# Service Bulletin

Category K (05)	Applicable Model/s All Models	Subject AUTOMATIC TRANSMISSION COOLER/LINE FLUSHING PROCEDURE	Bulletin No. 005/98
			Issued 04/22/98
			Revised 12/31/98

- This bulletin supersedes K 005/98 dated 04/22/98. The REPAIR PROCEDURE and WARRANTY INFORMATION has been revised.

FIGURE 1

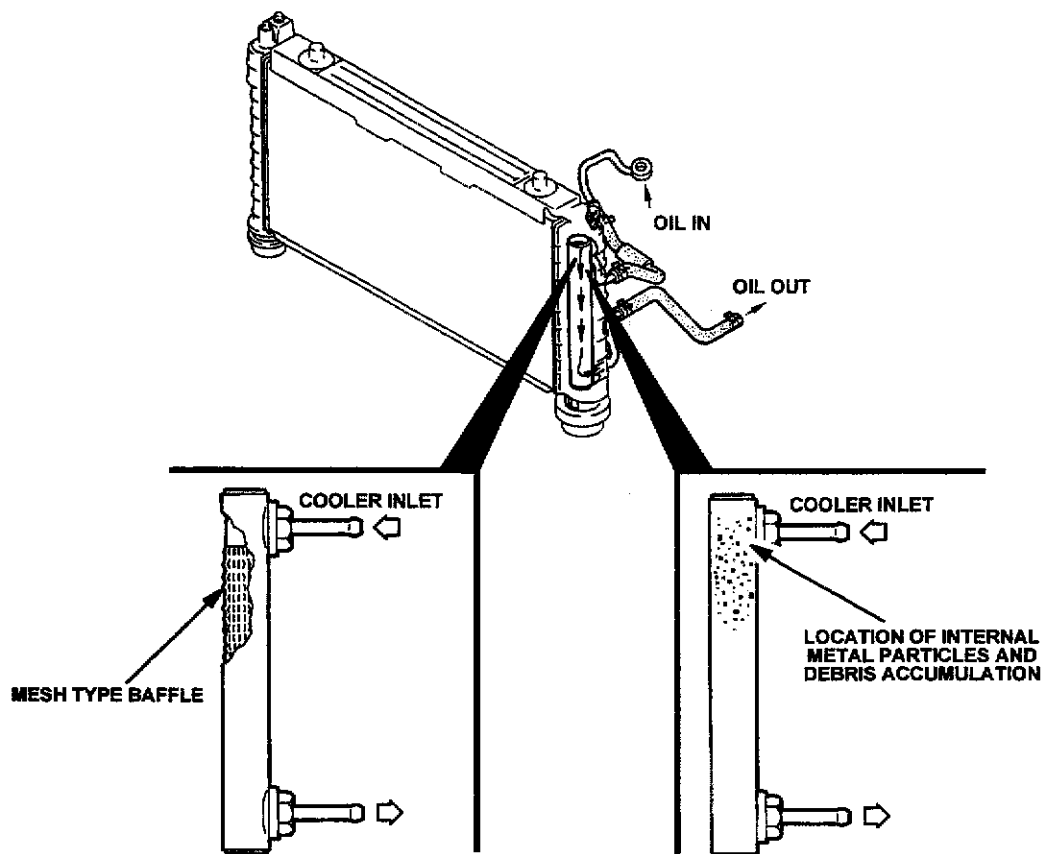
Automatic transmission (A/T) oil cooler/lines must be power flushed completely before an overhauled or replacement A/T is installed. One of the causes of repeat A/T failures is an internal automatic transmission fluid (ATF) restriction at the inlet side of the oil cooler. This restriction is usually caused by an accumulation of metal particles and debris (from a previous A/T failure) on the internal mesh type baffle of the oil cooler. Power flushing will remove the restriction by back flushing the cooler/lines followed by forward flushing to ensure full ATF flow. See **FIGURE 1** of a typical ATF cooler.

FIGURE 2

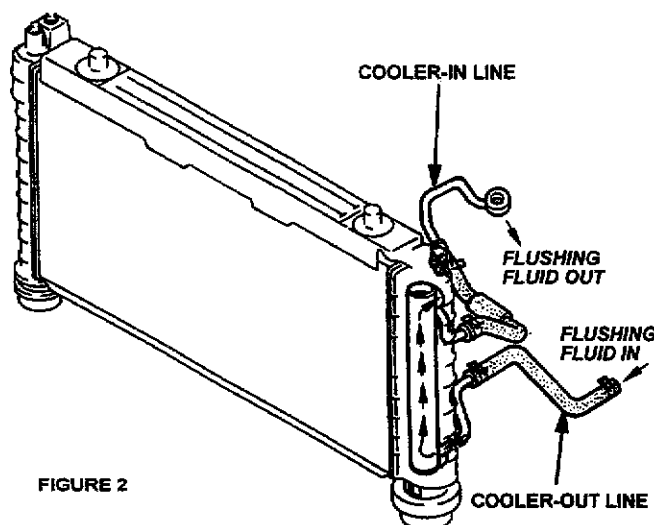
1. Using the Power Flushing Equipment manufacturer's instructions, connect equipment so the flushing fluid flows in the opposite direction of normal fluid flow. Refer to page 4 to determine normal fluid flow. See typical example of back flushing flow in **Figure 2**.
2. Flush oil cooler/lines until discharge fluid is clean.

FIGURE 3

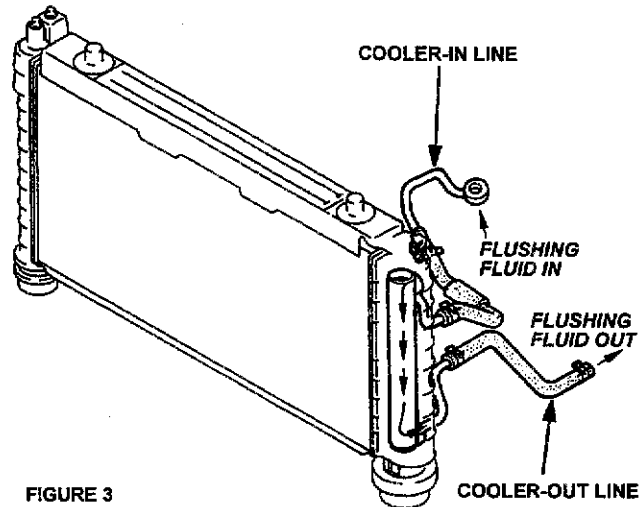
3. Connect power flushing equipment so the flushing fluid flows in the direction of normal fluid flow. Refer to page 4 to determine fluid flow. See typical example of forward flushing flow in **FIGURE 3**.
4. Flush oil cooler/lines until discharge fluid is clean.
